Access Compliance Report

Public Rights-of-Way

(Curb Ramps)

Intersection ID: 18365	Main Street: S_TRYON_ST	Cross Street: W_TYVOLA_RD	Location: SE
ADA ID: 2E7D1972F6A0	Ramp Type: PerpDiag	Initial Pass/Fail: Fail	Overall Compliance: No
Severity Score: 12.5			
Codes/Mitigation Info/Possible Solution		Field Measurements/Component Compliance

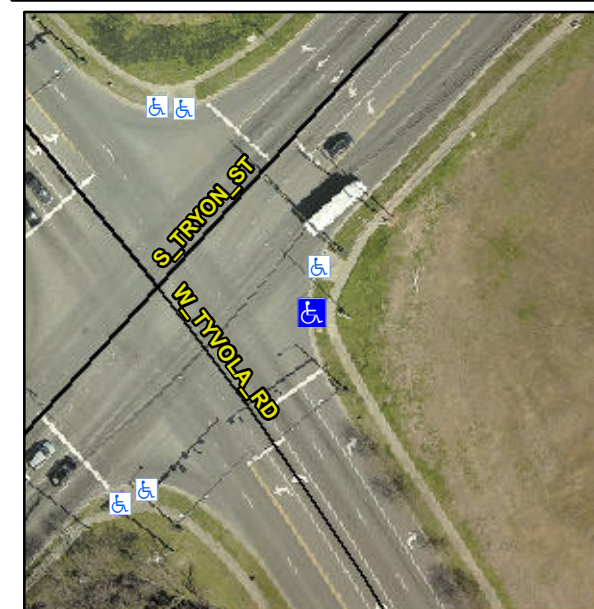
R304.2.2

Compliance	Description	Data	Compliance	Description	Data
N/A	Ramp Length (in)	78.0	No	Ramp Slope (%)	9.1
Yes	Ramp Width (in)	48.0	Yes	Ramp XSlope (%)	0.9
N/A	Flare Type LT	N/A	N/A	Flare Type RT	N/A
N/A	Flare Slope LT (%)	N/A	N/A	Flare Slope RT (%)	N/A
N/A	Flare Traversable LT?	N/A	N/A	Flare Traversable RT?	N/A
N/A	Landing Length (in)	N/A	N/A	DWS Provided?	N/A
N/A	Landing Width (in)	N/A	N/A	DWS Contrast?	N/A
N/A	Landing Slope (%)	N/A	N/A	DWS Length (in)	N/A
N/A	Landing X Slope (%)	N/A	N/A	DWS Full Width?	N/A
N/A	Landing Curb? (Y/N)	N/A	N/A	DWS Offset (in)	N/A
N/A	Shared Landing?	N/A			
N/A	Gutter Ponding?	N/A	N/A	Gutter Slope (%)	N/A
N/A	Gutter Lip Ht (in)	N/A	N/A	Gutter X Slope (%)	N/A
N/A	Painted X Walk1?	No	N/A	Painted X Walk2?	No
	X Walk 1 Direction	To NW		X Walk 2 Direction	To SW
N/A	X Walk 1 Width (in)	N/A	N/A	X Walk 2 Width (in)	N/A
	X Walk 1 Slope (%)	2.0		X Walk 2 Slope (%)	3.1
	X Walk 1 X Slope (%)	1.4		X Walk 2 X Slope (%)	2.0

Remove & Replace Curb Ramp With Two New Directional Ramps or Equivalent.
